TITLE: [PR-CM] Development Application DA10/0480 for the Demolition of Existing Dwellings and Construction of a Refreshment Room and Ancillary Function Centre at Lots 9 and 10 Section 4 DP 2974 Nos. 9-11 River Street, South Murwillumbah and Road 5190 Stafford Sreet, South Murwillumbah

Development Assessment

FILE NO: DA10/0480 Pt2

site plan

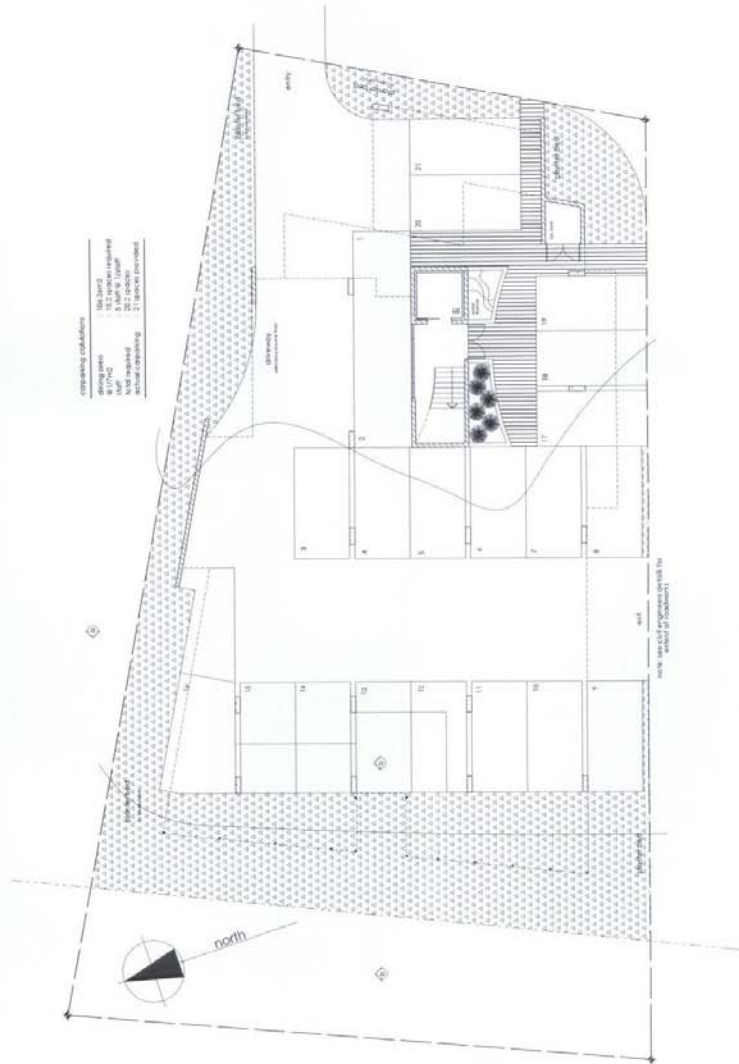
The applicant has provided a total of 21 onsite car parking spaces which will be provided on-site at Ground Level.

Vehicular access to the proposed ground level undercover car parking will be via an entry-only driveway in River Street and an exit-only driveway in Stafford Street.

The information provided was assessed by Council Engineer's who indicated that the applicant was required to provide all car parking spaces on the subject site or provide adequate arguments for alternate solutions. The applicant provided amended plans on 21 December 2010 with the provision of 21 on site car parking spaces and the removal of the Stafford Street parking option. Council officers determined that the proposed Function Centre and Refreshment Room is still out of scale for the size of the site. The amended plans have not reduced the overall size of the building rather the calculations have manipulated to comply with the number of car parking spaces provided on site. It is considered that the number of car parking spaces required to cater for the proposal is 31 spaces. With this calculation there is still a car parking shortfall of 10 spaces.

As a result of the car parking shortfall and the options being submitted to Council not being appropriate for the proposal, the proposed development is being recommended for refusal based on the lack of car parking to cater for the proposal.

first floor plan

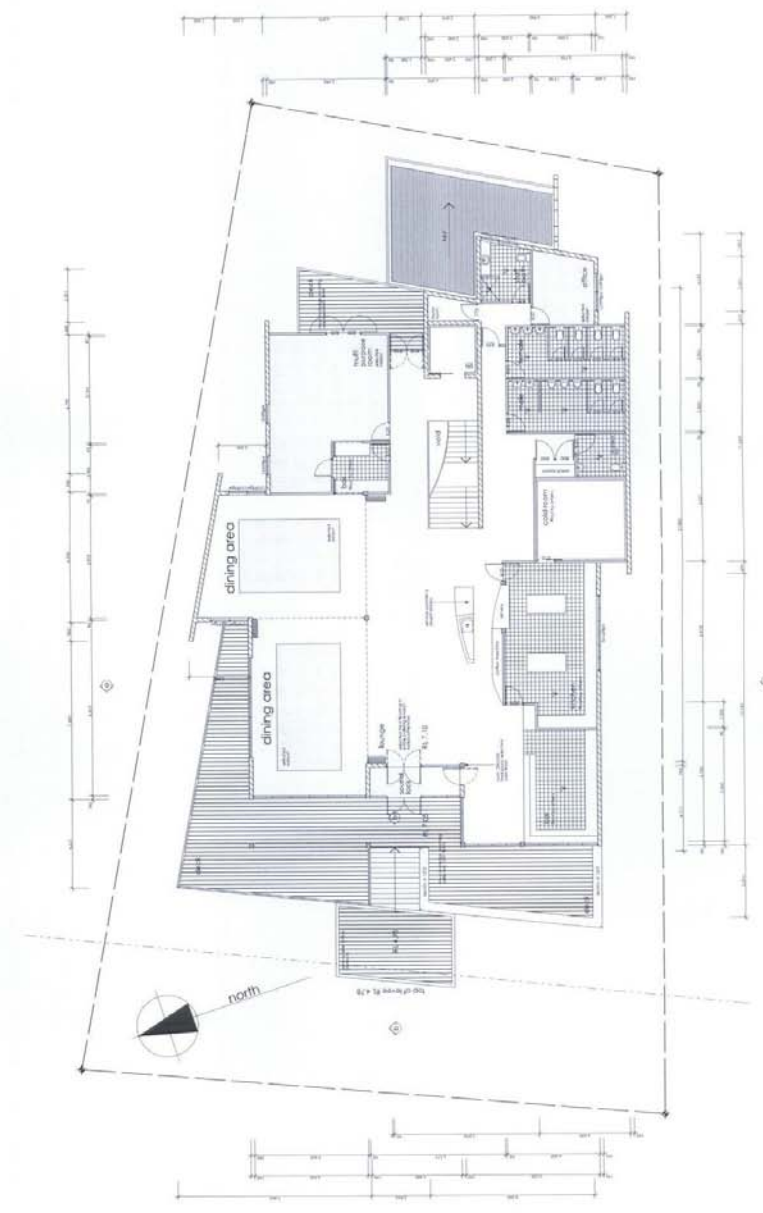
The plan provided by the applicant, WD10, provides a furniture layout plan which has 128 seats shown. Based on this it is considered that the proposed function centre component can cater for a much larger number of seats than what the applicant has proposed. If Council imposes a condition to cap the number of people for a function centre from a compliance perspective it will be very difficult to ensure that there will be a maximum of 79 seats. This can lead to numerous compliance issues if there are complaints in the future. It appears that the applicant has configured the calculations of the number of seats to ensure that car parking requirements are met with what car parking is proposed on site.

There is also a Multi-Purpose room which has not been identified as being utilised for either the Function Centre or the Refreshment Room. It is considered that a number of seats for the function centre component could potentially be increased or the dining area for the function centre could be increased creating a larger number of car parking spaces required.

dining area calculation plan

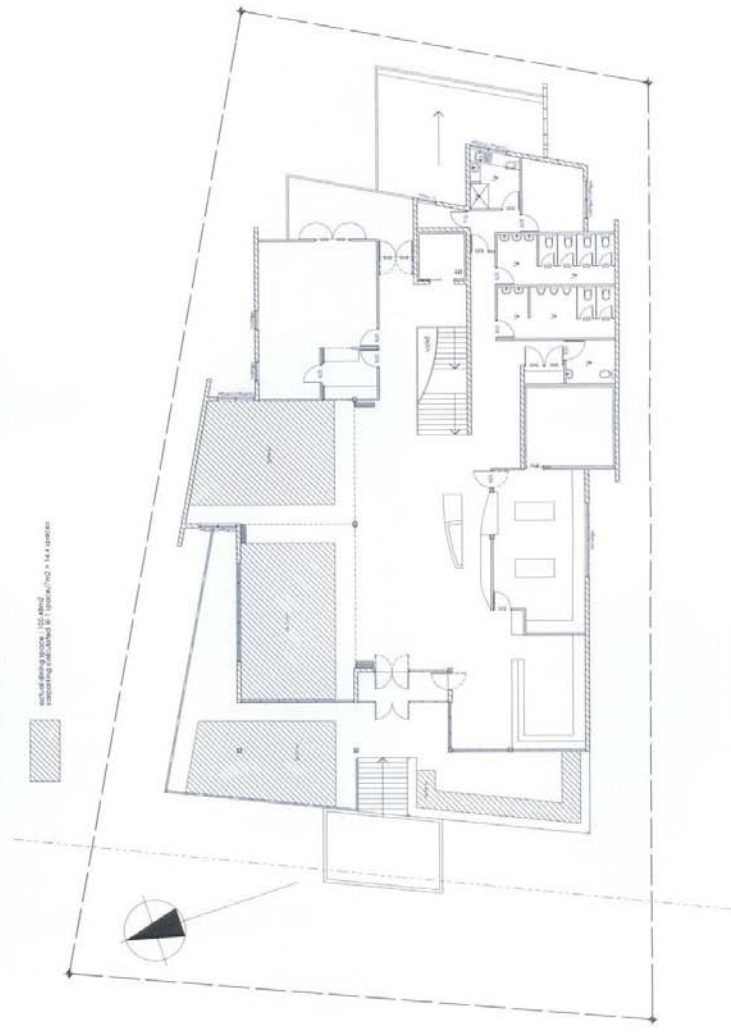
After discussions with internal sections within Council and the applicant it was considered that there are still issues surrounding calculations of the car parking. The plans have not been amended in regards to the Gross Floor Area of the development. It is considered that the applicant's calculations of the number of seats for the function centre and the selection of the dining area have been reduced to fit the number of car

It has been calculated that there is approximately 228m² of dining area and with the new number of 5 staff at peak times the development requires 37.6 spaces to be fully compliant. With a 20% reduction for ESD reduction the total number required for the refreshment room component is 31 car parking spaces. It is therefore considered that the proposal still has a shortfall of 10 car parking spaces.

However, it has been calculated that there is approximately 228m² of dining area and 5 staff at peak times. The applicant has created a dining area that is unreasonably undersized for the size of the proposed Gross Floor Area and only incorporates small sections of the floor area. If Council were to approve the proposal with this dining area it would be very difficult to ensure that the area nominated as 'dining area' will be the only area used.

Therefore it is considered that the development requires 31 car parking spaces for a refreshment room component including the 20% reduction for ESD.
